**CN Milton Logistics Hub –
Proposed Project Change to the
Sun-Canadian Pipeline Design
and Construction**

April 8, 2022
File: 160960844

**CN MILTON LOGISTICS HUB – PROPOSED PROJECT CHANGE TO THE SUN-CANADIAN PIPELINE
DESIGN AND CONSTRUCTION**

Figure No.
 2

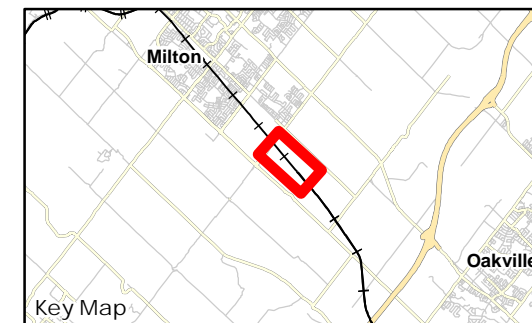
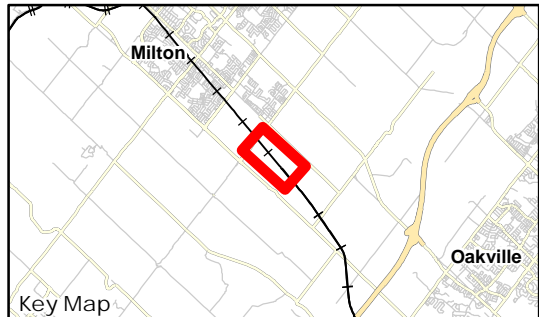
The existing pipeline, which consists of two separate pipelines running southwest-northeast across CN's property, is located within a single right-of-way (ROW) that transects the Designated Project Development Area (PDA) within the northwest portion of the proposed intermodal terminal area, as shown on Figure 1 in Appendix A. Through discussions with Sun-Canadian the preliminary plan has been refined. Rather than the original plan to relocate/move part of the pipeline to the north end of the proposed terminal at a depth ranging between 3 and 6 m, the refined design proposes to maintain the existing location/alignment and instead deepen it to approximately 14 m, as shown on Figure 2 in Appendix A.

Sun-Canadian Pipeline Component	Preliminary Design	Refinement
Location	Proposed realignment of two existing pipelines around the north end of the proposed terminal	Proposed deepening of one existing pipeline (323 mm) within the existing ROW
Pipeline Size	12"5/8 (321 mm)	NPS12 (323 mm)
Pipeline Depth	3 to 6 m below ground surface	13.8 m below ground surface
Pipeline Length	Approx. 890 m necessary for new alignment	Approx. 485 m – same as the original
Construction Method	Open cut for 800 m, with directional drill for 90 m beneath the CN mainline	No open cut trenching; directional drill for 485 m
Surface Disturbance	Approx. 800 m (full open cut, except for mainline crossing)	Limited disturbance for entry and exit points for drilling (less than 100 m)

Note that by going deeper – rather than moving the lines - a reconfiguration around the north end of the terminal would no longer be required and would avoid bends in the pipeline.

The horizontal directional drill (HDD) method involves an entry and exit pit at each end where the new alignment of pipeline will tie into the existing pipeline. The HDD will be completed in one bore from the entry pit on the south side of the PDA to the north side of the PDA crossing underneath the existing mainline and the planned terminal and tracks, following the existing alignment of the pipeline segments. The replacement segment will be installed at a maximum curved depth of approximately 13.8 m, approximately 7.8 to 10.8 m deeper than the original pipelines. Entry and exit pits will be cleared of

Figure No.
 2

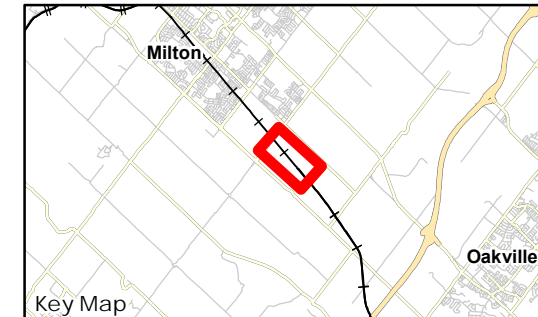
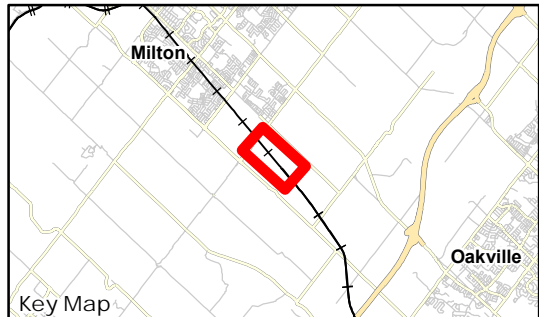
The originally proposed diversion (shown in Figure 1) of the Sun-Canadian pipelines ran from a point on the southwest edge of CN's property northward and around the northwest end of the proposed terminal, under the existing mainline tracks, and then eastward to a point on the northeast side of CN's property. The diversion route on the southwest side of the terminal/tracks largely parallels the proposed terminal access road, while the diversion route on the northeast side of the terminal/tracks cuts across agricultural fields. The described method of construction was open cut excavation and directional drilling.

As indicated in the EIS and in the response to Panel IR 4.1, CN has continued its ongoing discussions with Sun-Canadian during the detailed design process for the Project to determine the optimum approach to reconfiguration. Through that process, refinements to further reduce the potential environmental effects of this activity were achieved. The refined approach will involve maintaining the current pipeline route (rather than diverting it) by deepening it along its existing route (shown in Figure 2). This approach will eliminate almost all of the open cut excavation that would have been required to divert the pipeline around the northwest end of the terminal, with the exception of the required directional drilling entry and exit pits at either end of the reconfigured pipelines. As part of the installation, the new piping will be laid down on CN property along the pipeline right-of-way on the northeast side of the terminal/tracks. This activity does not require excavation.
